UNITED STATES PATENT AND TRADEMARK OFFICE

APPLICATION NO.	FILING DATE	FIRST NAMED INVENTOR	ATTORNEY DOCKET NO.	CONFIRMATION NO.
10/711,131	08/26/2004	Ronald Scott Bunker	154024-1	5130

FINAL REJECTION

Figure 9 of Maeda

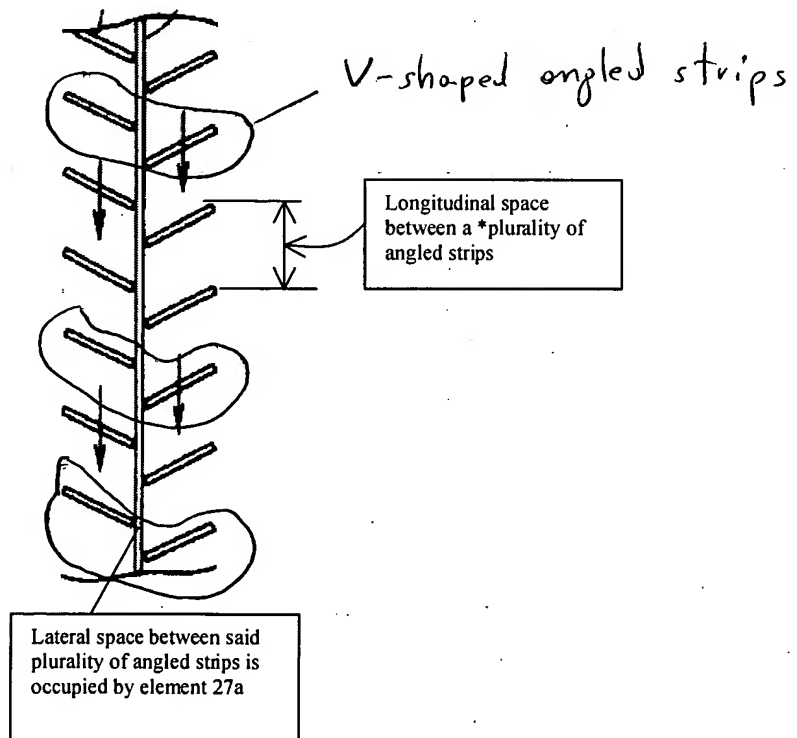
Maeda (Figures 9 and 10 particularly) teaches a combustor liner comprising a plurality of angled strips 27b integrally formed on an outer surface of said liner, said angled strip having a V shape and creating vortices on a cooling air flowing in a longitudinal direction across said outside surface of said combustor liner, said angles strips having a flat top, a space between each of said plurality of angles strips includes a lateral space and a longitudinal space, said lateral space disposed between each of said plurality of angled strips, each angled strip having a height (as illustrated in Figure 10), said angled strips have an angle from a horizontal direction from about 30-60 degrees, said combustion liner is enclosed by a sleeve (Figure 8),. See particularly Figures 9 and 10; cl. 9 ll. 49-55; and cl. 11 ll. 25-30.

Notice that said lateral space disposed between each of said plurality of angled strips is occupied by element 27a. However, nothing in the claims states that the lateral space disposed between each of said plurality of angled strips has to be an empty space. Therefore, the claim as written is anticipated by the occupied lateral space between each of said plurality of angled strips.

With respect to claim 1 and 17, applicant argues that Maeda does not teach a lateral space between each of the plurality of angled strips. Notice that Maeda does teach a lateral space disposed between each of said plurality of angled strips, said lateral space being occupied by element 27a. However, nothing in the claims states that the lateral space disposed between each of said plurality of angled strips has to be an empty space. Therefore, the claim as written is anticipated by the occupied lateral space between each of said plurality of angled strips.
